**Bitfire Development Kit
Bitfire Hardware Errata
Version 1.11**

Revision History		
Version	Date	Updates
1.10	050530	Document public release.
1.11	051019	Version 1.11 HW release notes added and fixed errata removed

1.2 Poor working traffic led indicators

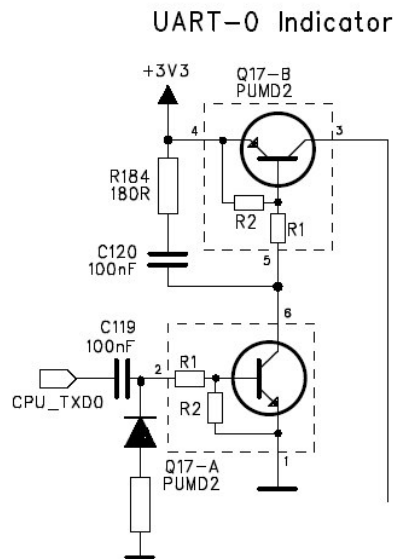
A new feature on V1.11 hardware was implementation of traffic flow indicators on interface ports. Low dataflow in conjunction with high baud rate these will not show traffic activity correctly. The procedure for patching to get correct behavior is the same for all channels. Refer to schematic page “Onboard integrated debug tools”.

Above picture shows TXD channel on UART-0. Place a diode like BAS216, 1N4148 or similar with anode from ground in series with a 180R resistor. This will ensure that positive voltage is seen on the base of Q17 even though the previous packet had a short low level duration.
